CLIENT:	GILBANE BUILDING COMPANY		
SYSTEM:	VRC ELEVATOR		
ADDRESS:	1095 SOUTHERN BLVD, BRONX, NY 10459

TITLE:	CIVIL WORKS		
SCALE:	N/A	DATE:	04/23/24
DRAWING NO:	VRC-UHP-01	DRAWN:	CHECKED:
		SHEET:	1 OF 4

TITLE: EQUIPMENT DESCRIPTION			
SCALE: N/A	DATE: 04/23/24	DRAWN:	CHECKED:
DRAWING NO: VRC-UHP-02	SHEET:	2 OF 4

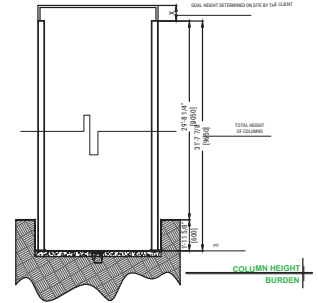
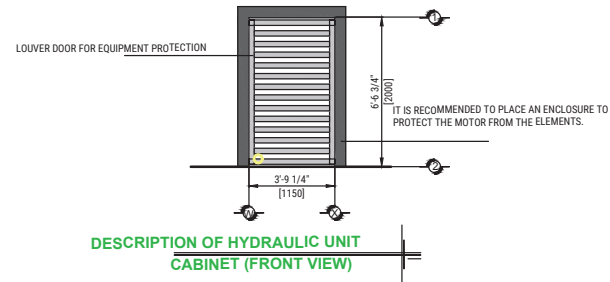
Include soft control cable from 1st box to PLC box.
